D/DRC Case

1410 Geiger Avenue

N DESIGN/DEVELOPMENT REVIEW COMMISSION
DESIGN REVIEW DISTRICT
CONSENT AGENDA
EVALUATION SHEET
Case #2

NATURE OF REQUEST: Request for a Certificate of Design Approval for exterior changes, addition and attached carport

Proposed Site plan of 1410 Geiger Avenue

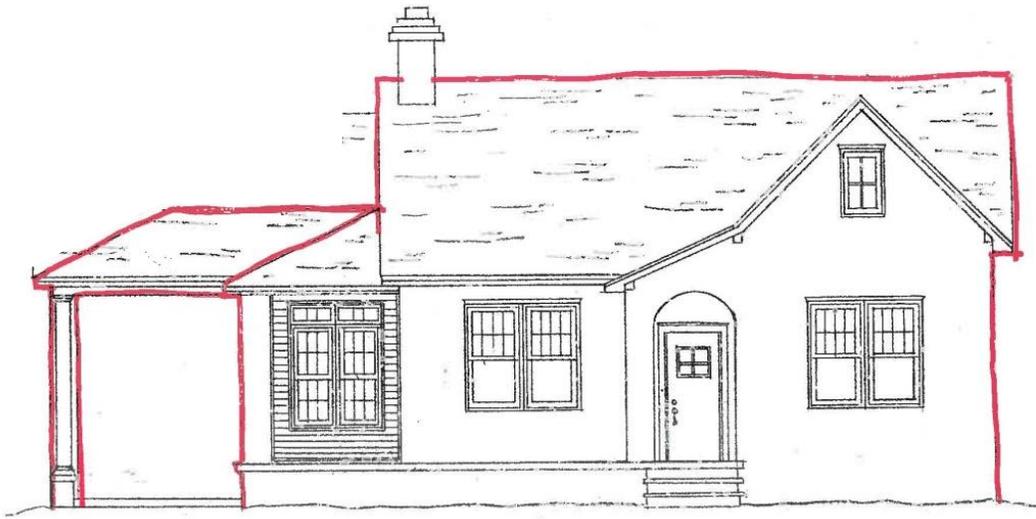
The new rear addition will be one story in height and set back from the principle façade. The new carport will be set back from the principal façade and will have a low sloped roof.

The addition will be limited to one story and will have a smaller footprint than the first floor of the original house.

The massing of the addition is compatible to the building and will be largely hidden from view, except for a portion on the east side. There is a carport proposed that will create a different massing than what is typical for this style of house, however, a historic building to the east has a similar carport set back on the east elevation and it is known to have been on the c. 1930s house as early as 1950. In fact, it may have been original to the building but its visibility from the public right of way is limited and it features brick columns to match the house, as well as a low-pitched roof. The carport will be largely attached to the new addition and will be at the rear of the existing building, minimizing its impact on the massing of the historic house.

- *A finalized design and window schedule to be submitted to staff.*
- *The smooth side of proposed cement-fiberboard must be used on addition. No texture.*
- *Carport columns and final detailing to be deferred to staff.*
- *The carport roof be lowered and made into a hip as per attached renderings altered by staff.*
- *All details deferred to staff.*
